Product Change Notice

Removing portion of heatsink fin located behind RAID upgrade key.

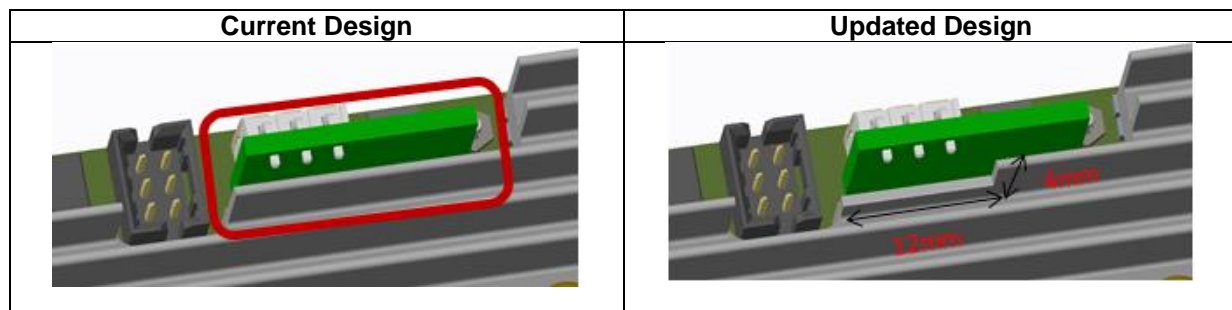
Current 9460-16i and 9460-8i heatsink design increases the risk of shorting the RAID upgrade key if the board is mishandled. This could occur if the handler puts too much stress on the RAID upgrade key causing it to bend into the heatsink. This may cause the component mounting pins on the RAID upgrade key to touch the heatsink resulting in a short.

To lessen this risk, a portion of the heatsink fin behind the RAID upgrade key is being removed.
